A d d e n d u m

Iowa Department of Transportation
Office of Contracts

Date of Letting: October 15, 2013
Date of Addendum: October 9, 2013

B.O.	Proposal ID	Proposal Work Type	County	Project Number	Addendum
103	59-0652-020	PCC OVERLAY - UNBONDED	LUCAS	NHSN-034-6(88)--2R-59 NHSX-065-2(20)--3H-59 STPN-014-1(12)--2J-93	15OCT103.A02

B.1

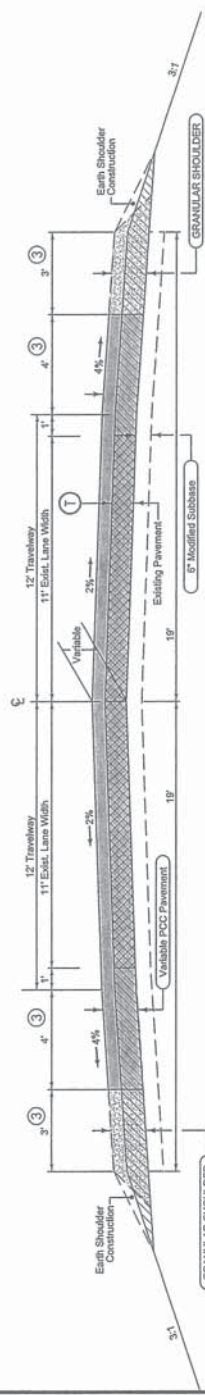
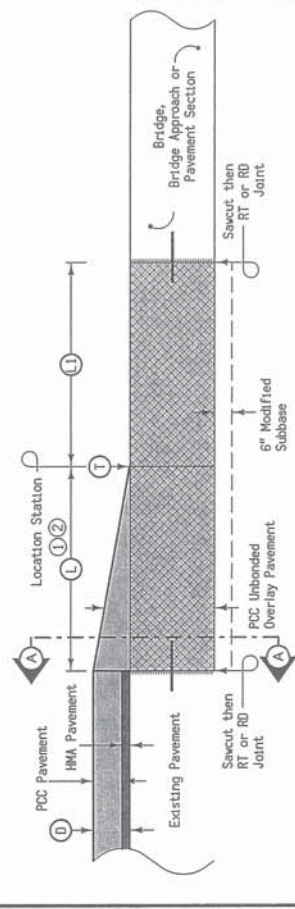
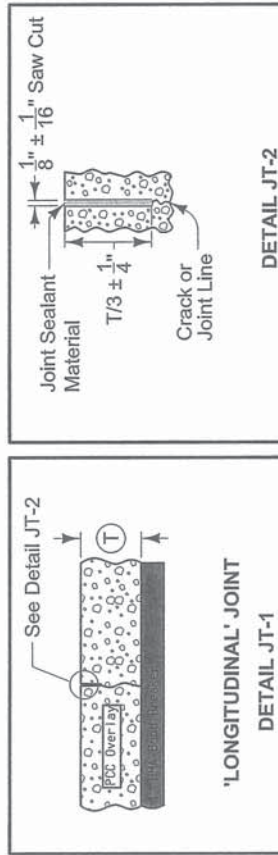
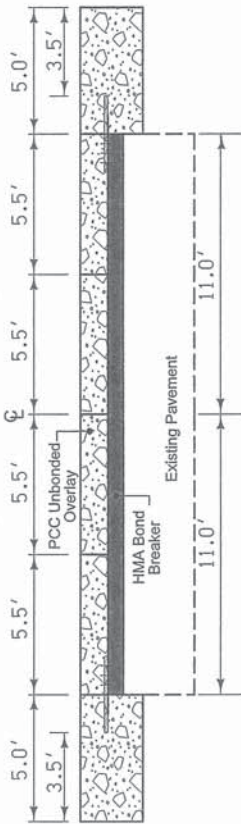
Replace plan sheet B.1 with attached plan sheet B.1

Note, Changes on plan sheet B.1:

Typical Overlay:

- Took off Existing Pavement Depth measurement and added Note:
For Existing Pavement Detail see 1954 Paving detail on B sheets.

Typical 7307 M:

- Added 6" Modified Subbase to Section A-A and Detail.
- Added to Tab. Modified Subbase Column.
- Increased Class 13 values to reflect Modified Subbase inclusion.

SHEET NUMBER B.2

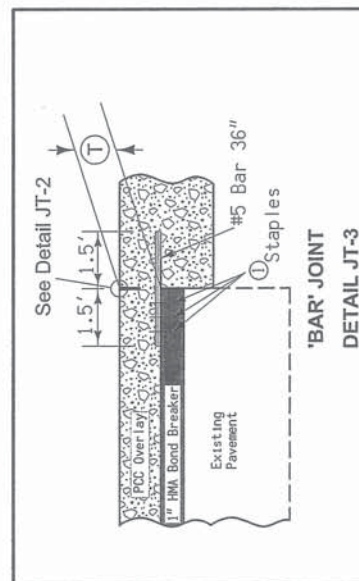
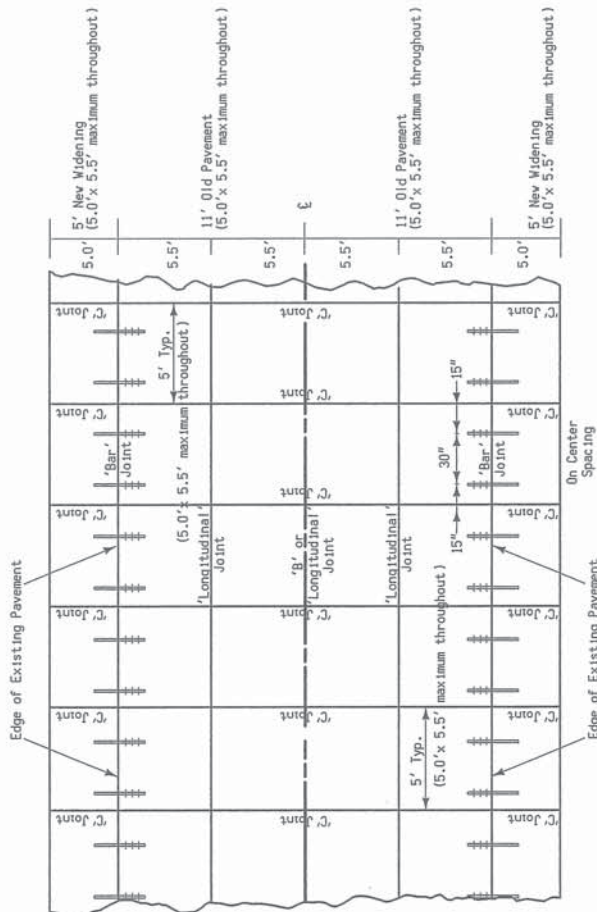
Replace plan sheet B.2 with attached plan sheet B.2

Note, Changes on plan sheet B.2:

Typical Cross Section and Joint Diagram:

- Added to Note:

or:

The tie bars can be inserted into the plastic concrete during paving if the amount of movement is minimal and acceptable to the Engineer. If the Contractor can demonstrate satisfactory installation during paving, the center of the tie bar is to be placed to a depth of 3 inches (measured from the surface of the PCC overlay) into the plastic concrete.

PAVED SHOULDER AT GUARDRAIL

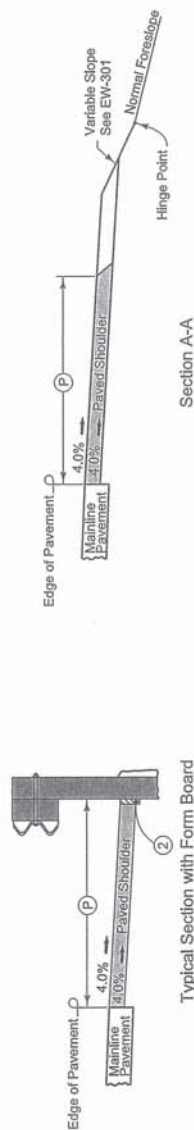
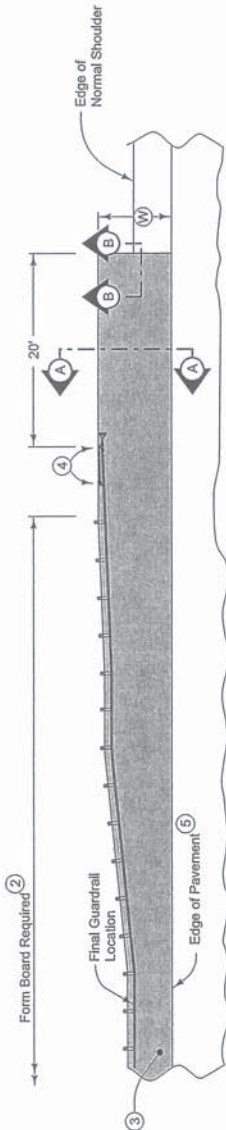
Typical 7156 is now modified by:

Top note:

- Either 6" HMA Paved Shoulder at Guardrail or PCC with the following jointing layout.

Circle note 5 changed to:

- 'BT-5' joint for PCC Shoulder.
- 'B' joint for HMA shoulder.

Removed from the drawings any indication of subbase need.
